DART SERVICE INSTRUCTION

TO AMEND IIN-D412-704 REV. C OR EARLIER

AND ICA-D412-704 REV. 4 OR EARLIER

PURPOSE

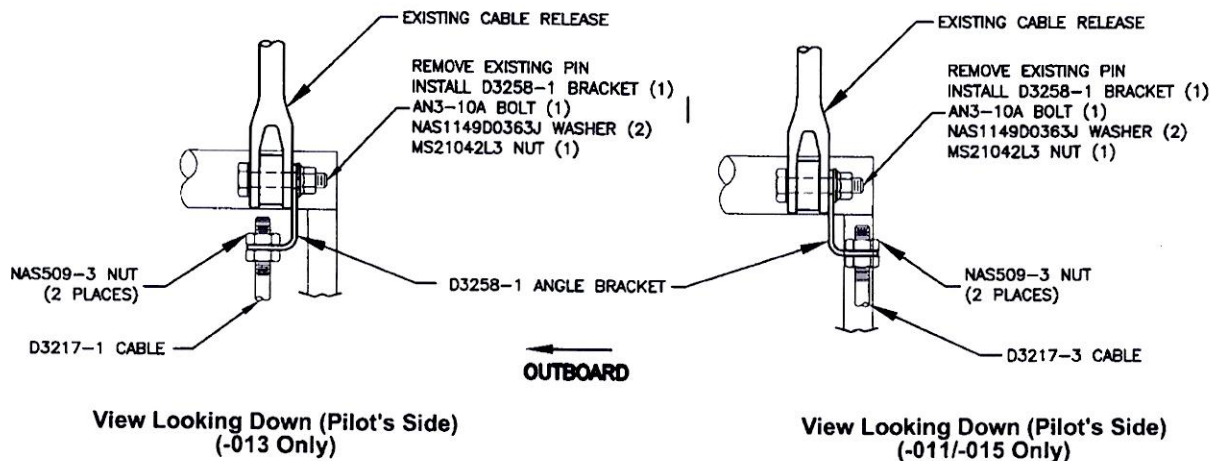
PART LIST CORRECTION

Revise Part Lists in IIN-D412-704 & ICA-D412-704 as follows:

NOW

Qty -043	Qty -045	Part Number	Description
X		D205-704-043	CABLE ASSEMBLY (205)
	X	D412-704-045	CABLE ASSEMBLY (210/212/214/412)
1	1	AN3-10A	BOLT

WAS

Qty -043	Qty -045	Part Number	Description
X		D205-704-043	CABLE ASSEMBLY (205)
	X	D412-704-045	CABLE ASSEMBLY (210/212/214/412)
1	1	AN3-13A	BOLT

Figure 5 - Detail L or Figure 25-4 - Detail L

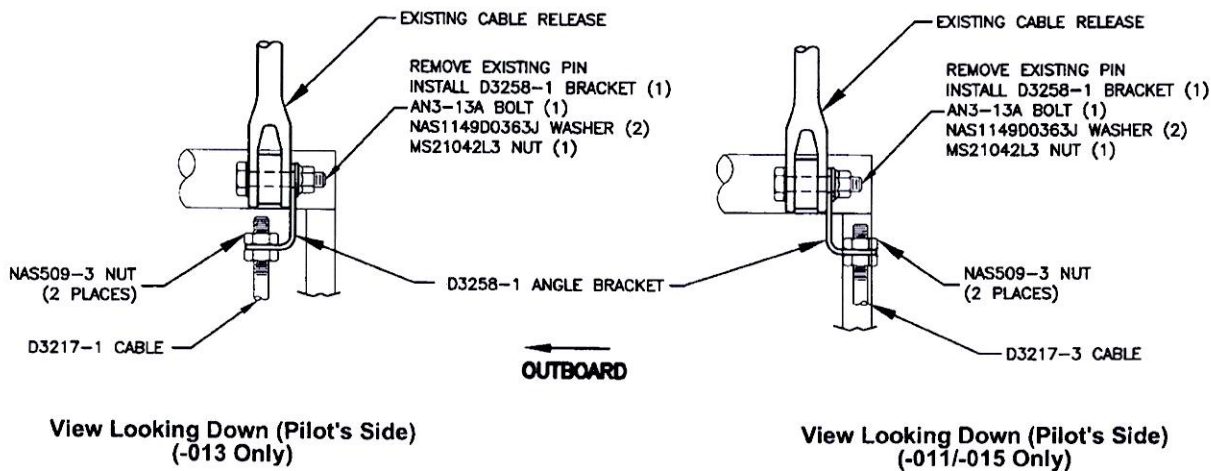
The purpose of this Dart Service Instruction is to correct part number error in Installations Instruction IIN-D412-704 Rev. C or earlier and Instructions for Continued Airworthiness ICA-D412-704 Rev. 4 or earlier. The AN3-13A bolt should be replaced with an AN3-10A bolt in Figure 5 - Detail L in IIN-D412-704 and Figure 25-4 Detail L in ICA-D412-704. See sheet 2.

FIGURES CORRECTION

Revise Detail L Figure 5 of IIN-D412-704 and Detail L Figure 25-4 of ICA-D412-704 as follows:
